MILITARY SPECIFICATION

BUCKLE, GENERAL OFFICERS' BELT, GOLD PLATED

This amendment forms a part of Military Specification MIL-B-40006C (IH), dated 31 March 1977, and is approved for use by all Departments and Agencies of the Department of Defense.

FIGURE 1

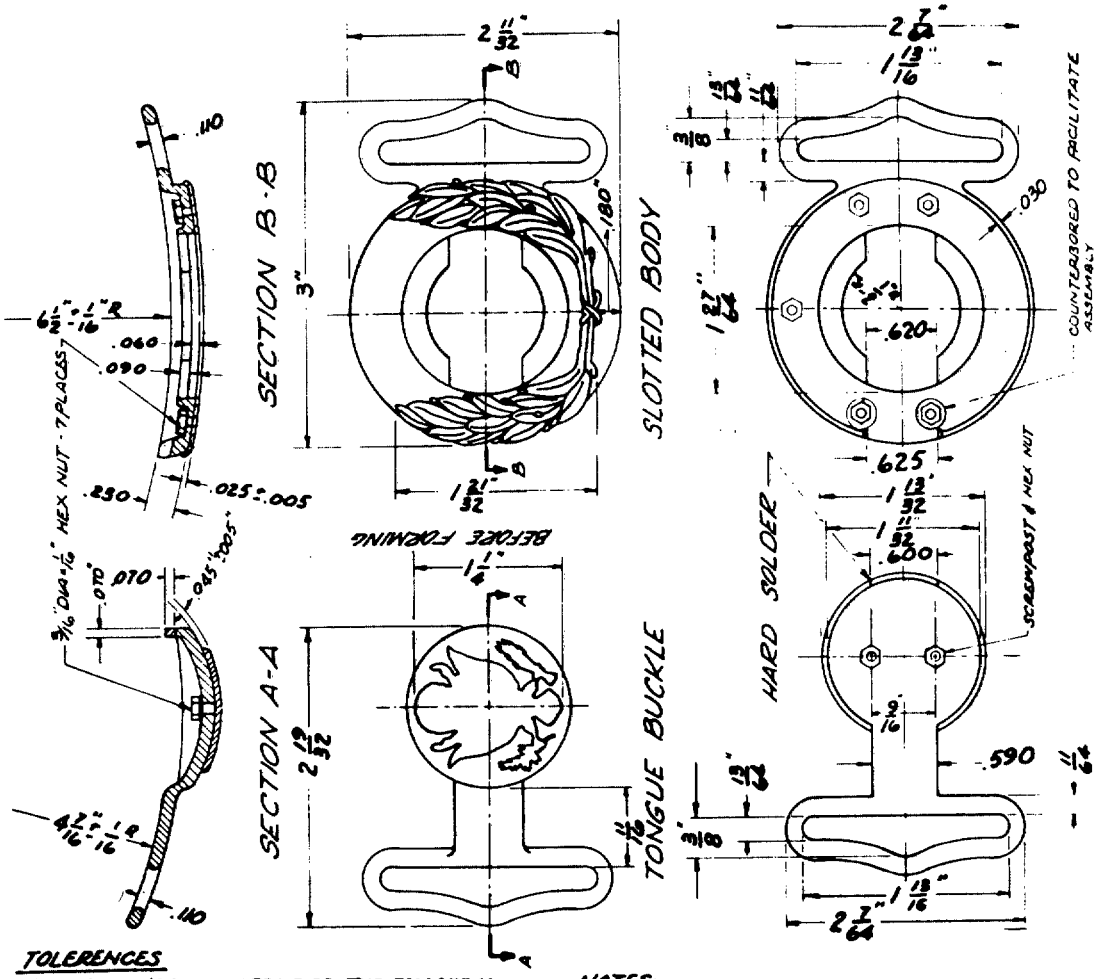
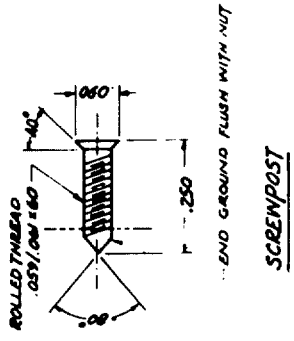
Para. 3.3.2 Delete in its entirety and substitute. "3.3.2 Screw post and thumb nut. The screw post and thumb nut shall be fabricated from any type brass and shall conform to the details and dimensions of Drawing B-6-3.

Delete "Figure 1" and substitute new "Figure 1."
